File 421422

May 26, 2023

Re: 505-533 Yonge Street, City of Barrie
Response to 1st Submission Comments – Traffic Impact Study

Figure 1: Site Plan - Revised

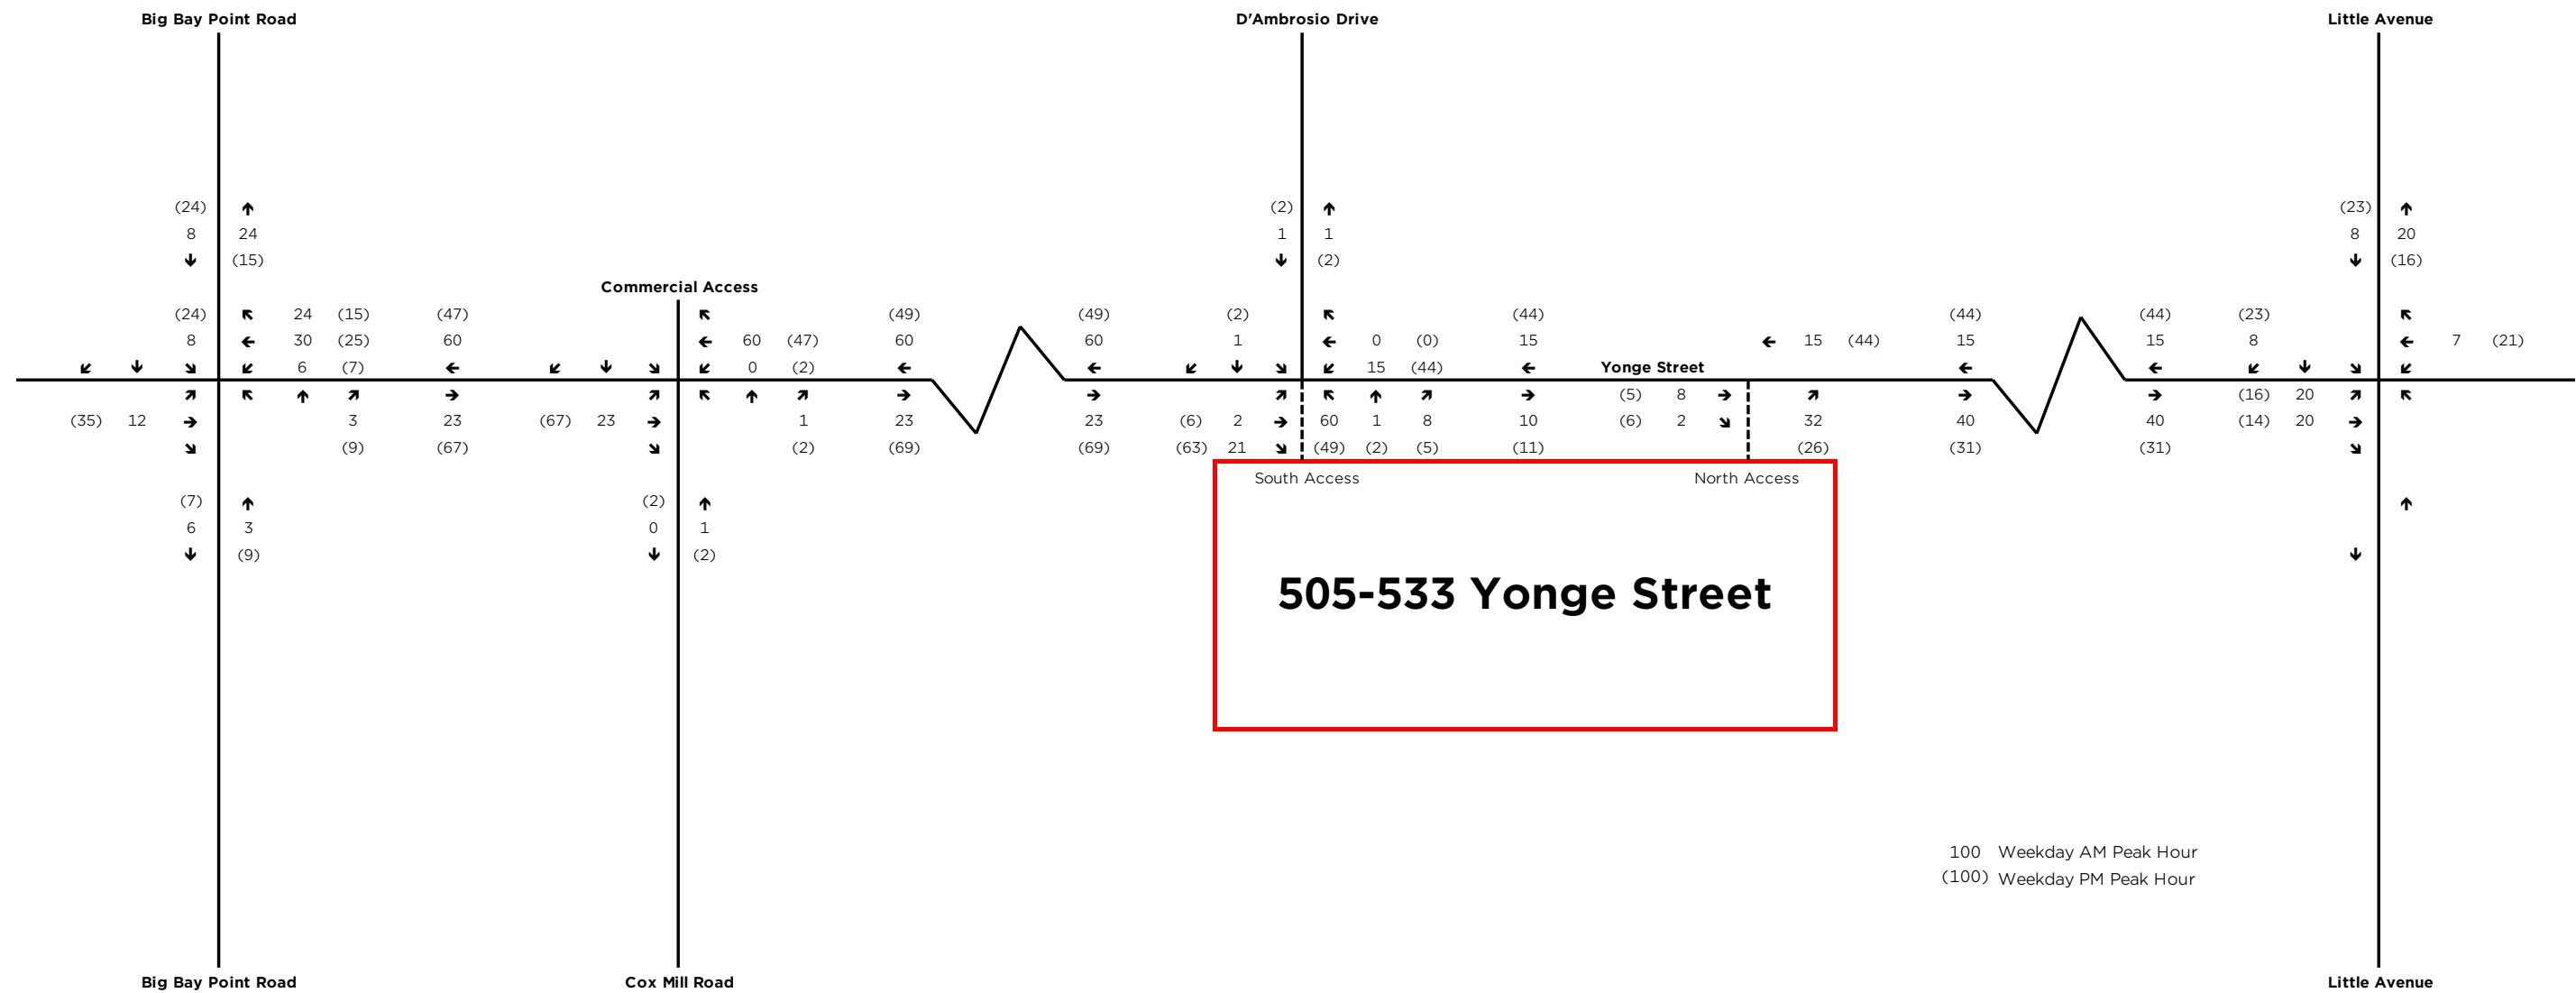
Comment: *In accordance with the Official Plan Section 5.4.2.2 Development of property adjacent to Arterial Roads should be encouraged to design access onto the site which would minimize the impact on the adjacent Arterial Road. Such designs may include shared access points, controlled directional access and the use of access points onto Collector or Local Roads. To this regard the applicant acknowledges that the northern access shall be restricted to a right turn in / right turn out only access and a warning clause shall be registered on title regarding the movement restriction.*

The proposed north access onto Yonge Street shall be restricted to a right turn in / right turn out and shall be designed in accordance with Transportation Association of Canada – Geometric Design Guidelines.

Comment: *The applicant shall be required to design the south access in alignment to D'Ambrosio Drive and the intersection shall be designed in accordance with Transportation Association of Canada – Geometric Design Guidelines. To this regard, the south access shall be widened to accommodate an eastbound left turn lane. The storage requirement for the left turn shall accommodate the 95th percentile queue length as identified in the Transportation Impact Study.*

Response: Acknowledged. The north access point to Yonge Street has been re-assessed (see below) with a right-in/right-out configuration, with left-turning traffic re-assigned to the signalized intersection of Yonge Street with D'Ambrosio Drive/site access.

Response: Given constraints at the south limits of the property and the potential impacts to the proposed building, shifting the south access further south and widening it to accommodate a left turn lane is not feasible; however, through discussions with City staff, a revised design was agreed upon that, to the extent possible, mitigates the City's concerns. The access was revised to accommodate the following:

- 9.0 metre width;
- 1.5 metre offset between the centre line of the site access and the centre line of D'Ambrosio Drive; and
- 10 metre x 5 metre daylighting triangles.

The revised access design has been incorporated into the site plan.
